Ilonka Aylward's Complaint

Exhibit 4

Notice of Intent to Commence Civil Action under Sections 301, 401, 402, 404 & 505 of the Clean Water Act and the North Carolina Sediment Pollution Control Act of 1973

The threatened and violations on 2813 Hinsdale Street, Charlotte, North Carolina, are incident to the City&Storm project known as "Hinsdale-Tinkerbell Stormwater Drainage Improvement Project" with the drainage area of approximately 240 acres and current estimated cost of construction \$7,900,000.

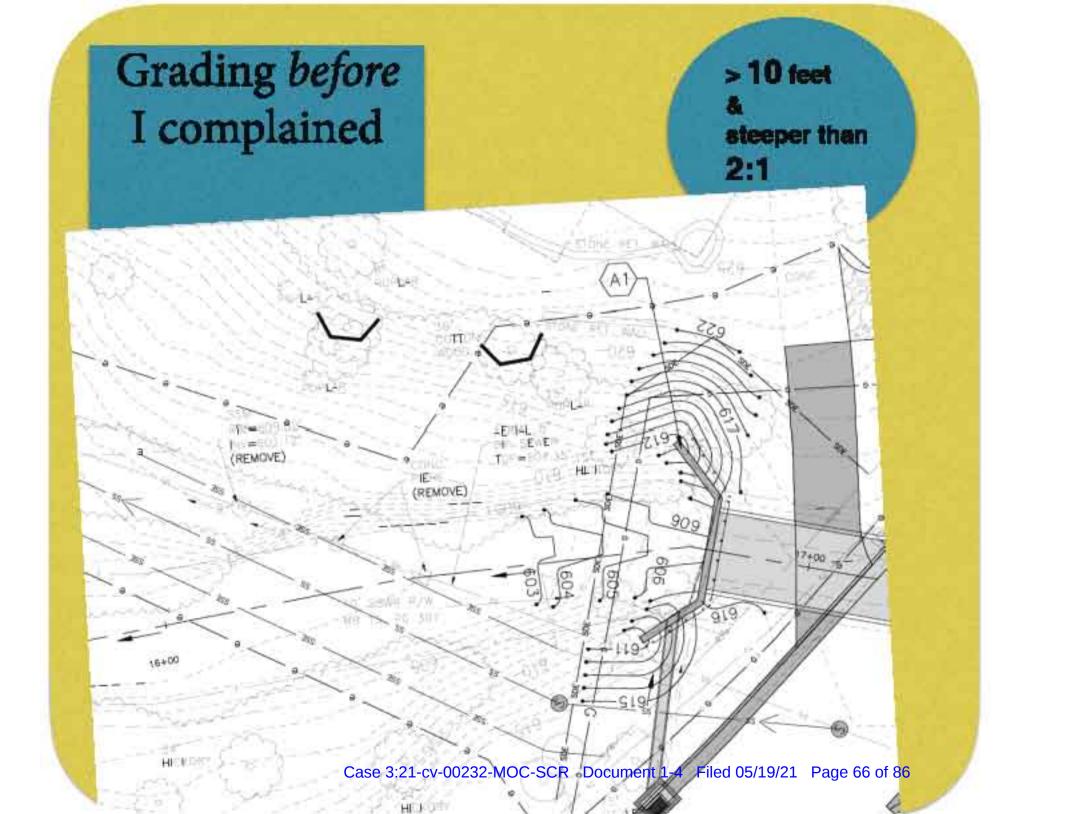
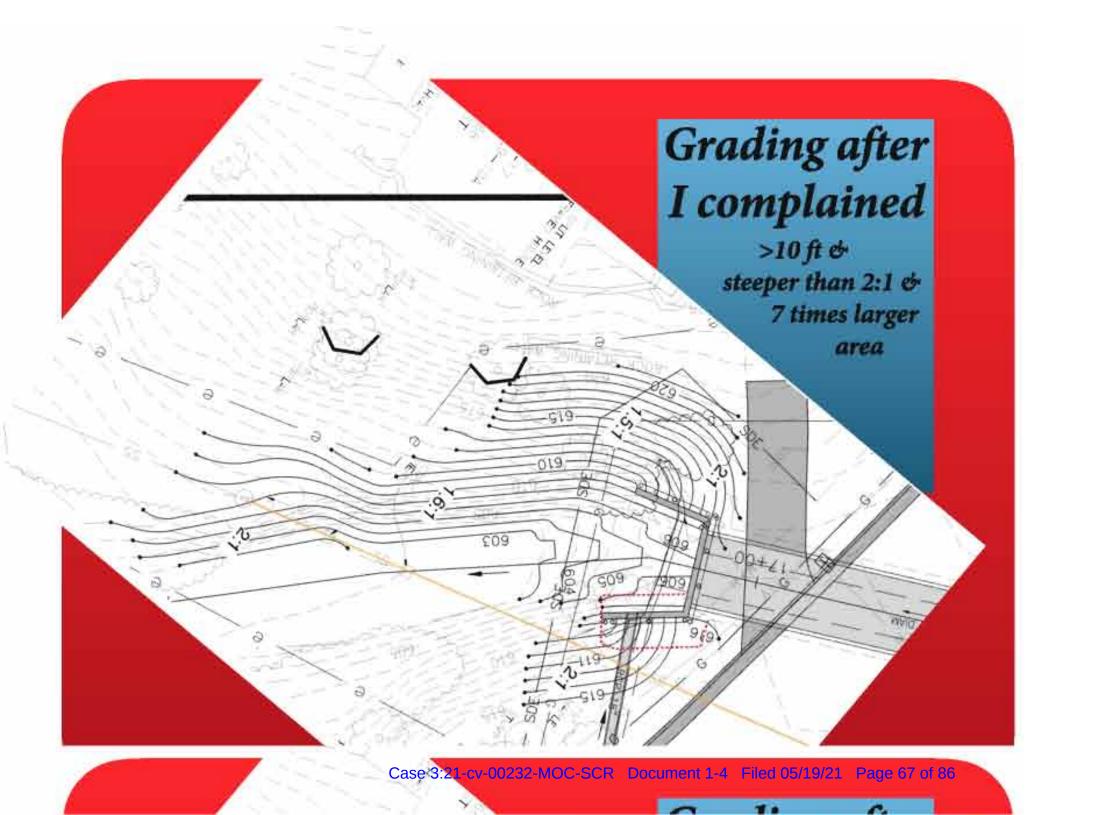
The insert here shows a close-up of grading threatened by CMSWS in early 2019, as compared to after I complaint to City Engineer in late 2019. The area to be graded is increased at least 7 times.

Note that *Department of the Army Regional General Permit* specifically commands: "Tree and shrub cover along the stream should be retained as much as possible in order to stabilize the stream banks."³

Exhibit Only - Not for Construction

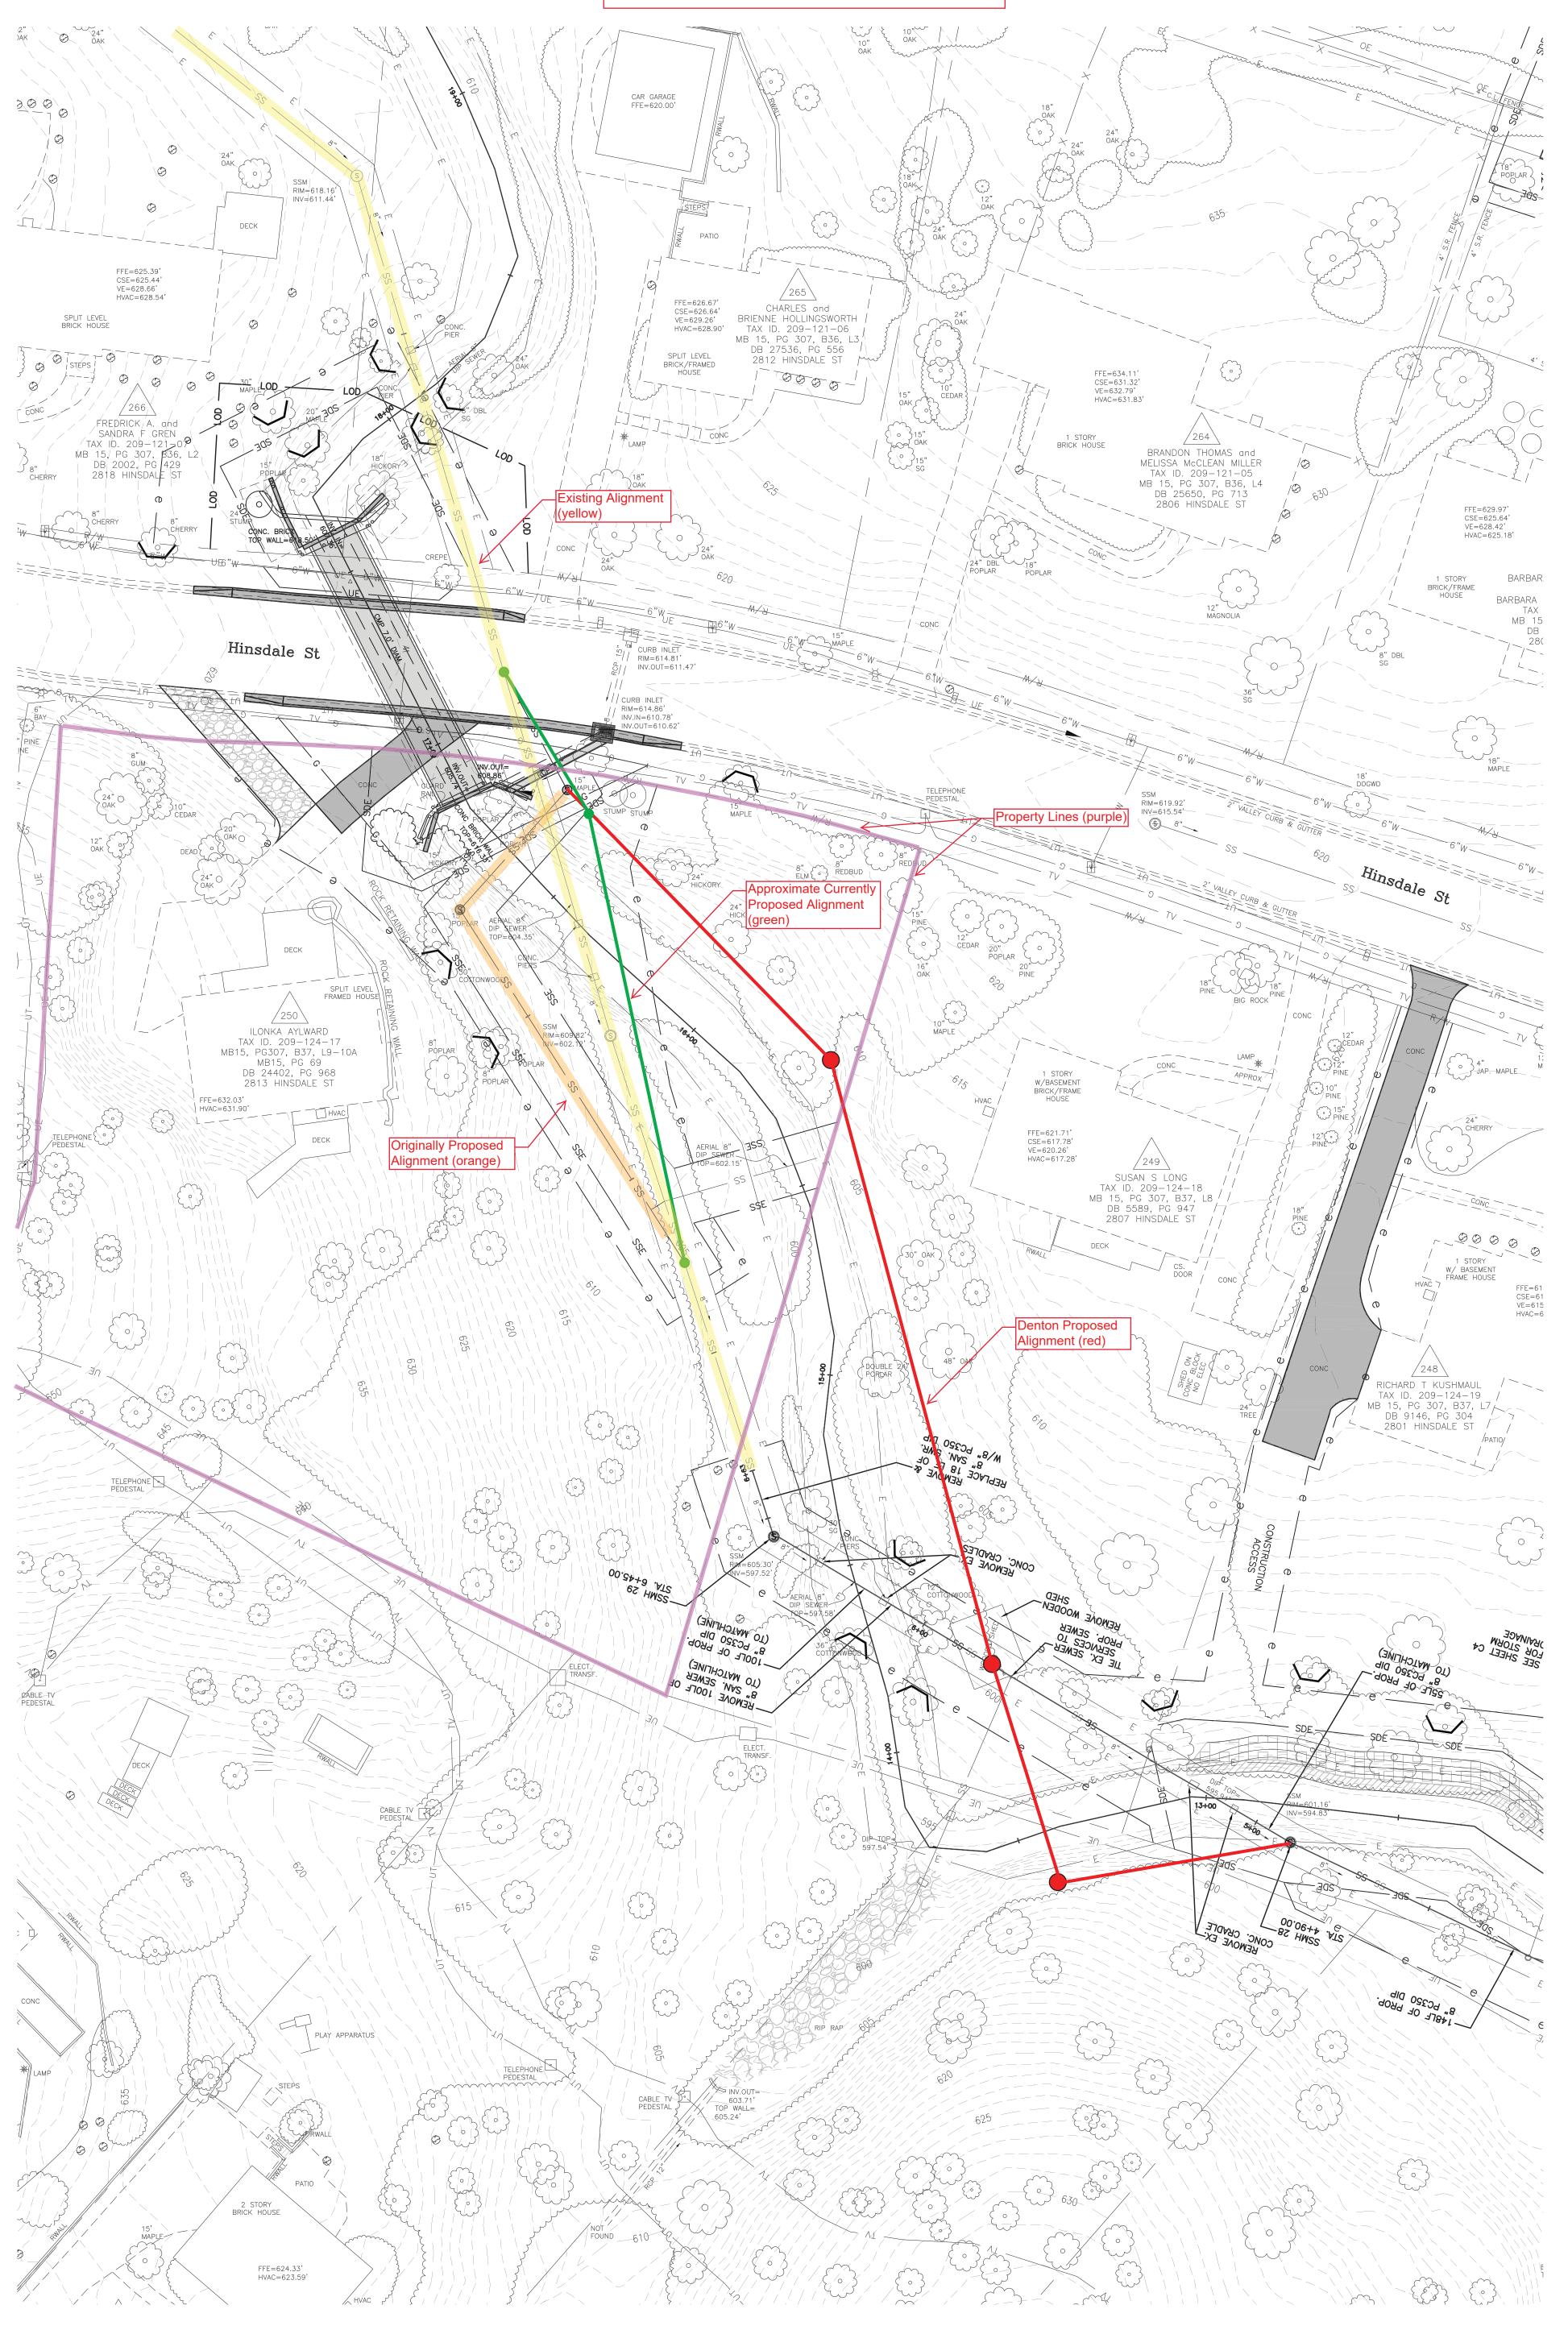
This correspondence is to document the findings of a review of the proposed plans to replace the storm drainage culvert on Hinsdale Street, adjacent to your property. I have reviewed, in particular, the slope at the southwest corner of the culvert. The slope closest to your residence, is proposed to be 1.5-1. The Slopes at all the other corners of the culvert is proposed to be 2:1. A typical and maintainable maximum slope for soils in the piedmont of North Carolina is 2:1. Slopes steeper than 2:1 are subject to slope failure and erosion due to the inability to obtaining and maintain an adequate vegetative cover. This proposed unstable slope is uncomfortable close to your residence and it is my recommendation that a redesign in this area is warranted. Grading in this area will destroy the existing stable vegetation and structures and will subject the house foundation to blasting and vibration from moving construction equipment.

My recommendation is that the end of the wing wall be rotated toward the creek and away from your residence. This would reduce the cut, reduce the slope, and eliminate the risk to your residence. Because the creek is bending to the left in this location, angling the wingwall away from your residence will also protect the creek bank in this area. This proposed change shouldn't cost any additional money to construct and can be constructed below the 616 contour which will limit the danger to your house and reduce the city's easement cost.

You also indicated that the city contractor is planning on storing materials and equipment on your property during construction. The only possible location for this would be across the creek from your house on the triangular lot of your property bounded by the creek, the road, and your eastern property line. Using this area wouldn't cause a significant disruption to your residence or disturb an area that might erode and cause structural damage to your house. Please review my comments and let me know if you have any additional questions.
